BUILDING CODE OF AUSTRALIA COMPLIANCE ASSESSMENT REPORT

Alterations and additions to existing building

49K French Avenue, Frenchs Forest

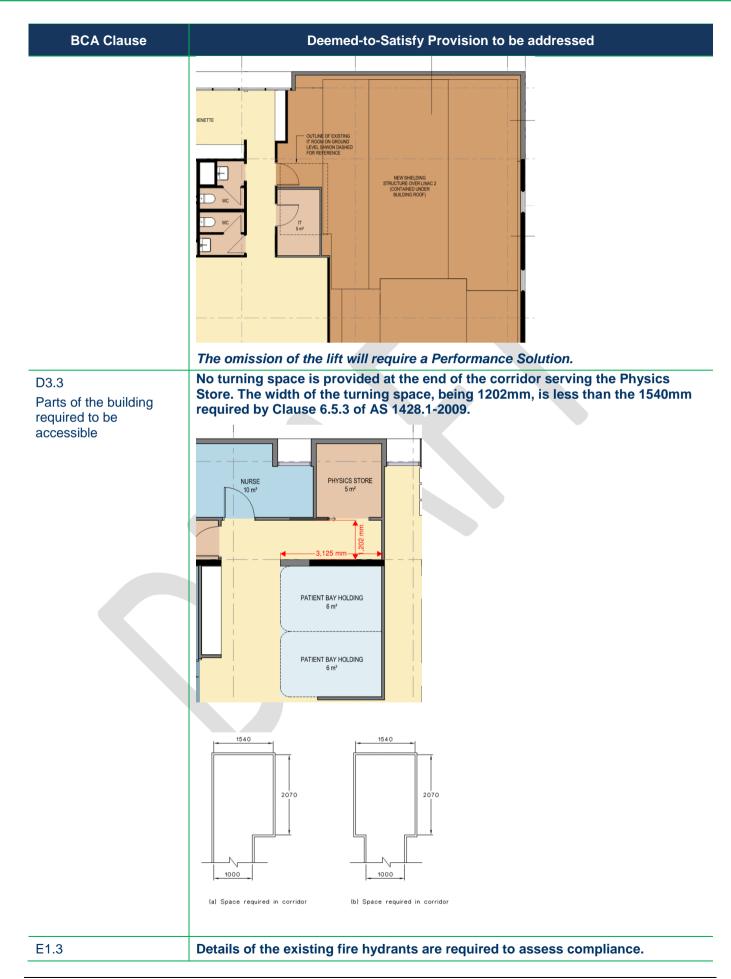
Where the first-floor works require an application for approval (i.e., in isolated constitute *exempt development* under the Codes SEPP) then a continuous path of travel is required to that part.

A continuous path of travel in the subject building would require a passenger lift.

The proposed deletion of the boardroom and construction of a plant room would require an approval and therefore under the provisions of the Disability (Access to Premises – Buildings) Standards 2010, a lift will be required.

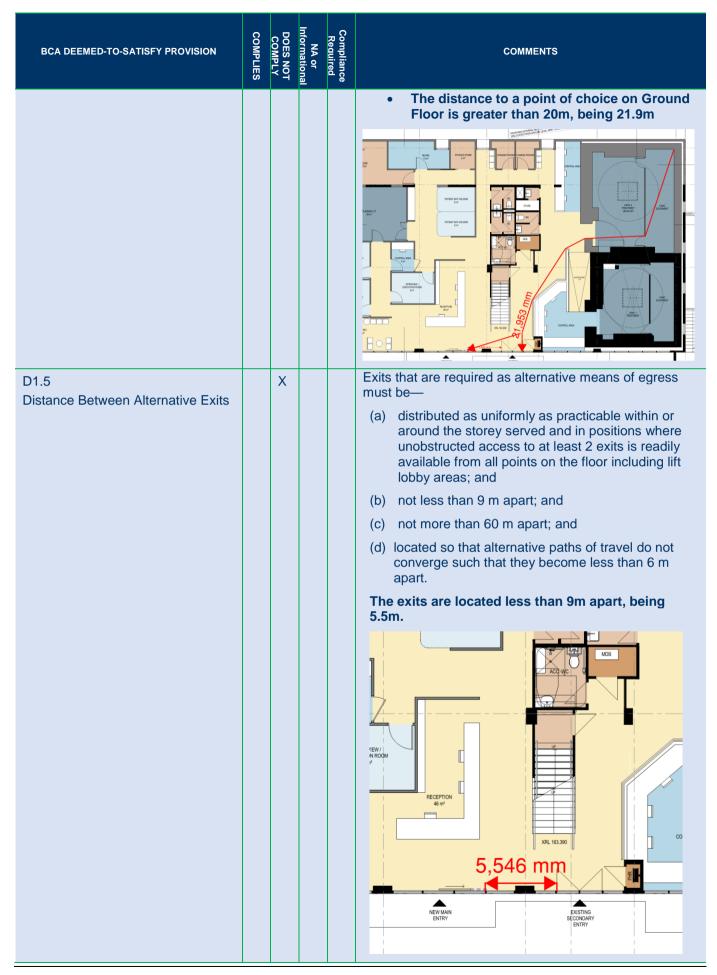
BCA Clause Deemed-to-Satisfy Provision to be addressed The distance to a point of choice on Ground Floor is greater than 20m, D1.4 being 21.9m **Exit Travel Distances** It is recommended that this is addressed by a Fire Engineered Performance Solution. The exits are located less than 9m apart, being 5.5m. D1.5 Distance Between Alternative Exits It is recommended that this is addressed by a Fire Engineered Performance Solution. The existing doorway is swinging against direction of egress. D2.20 Swinging Doors
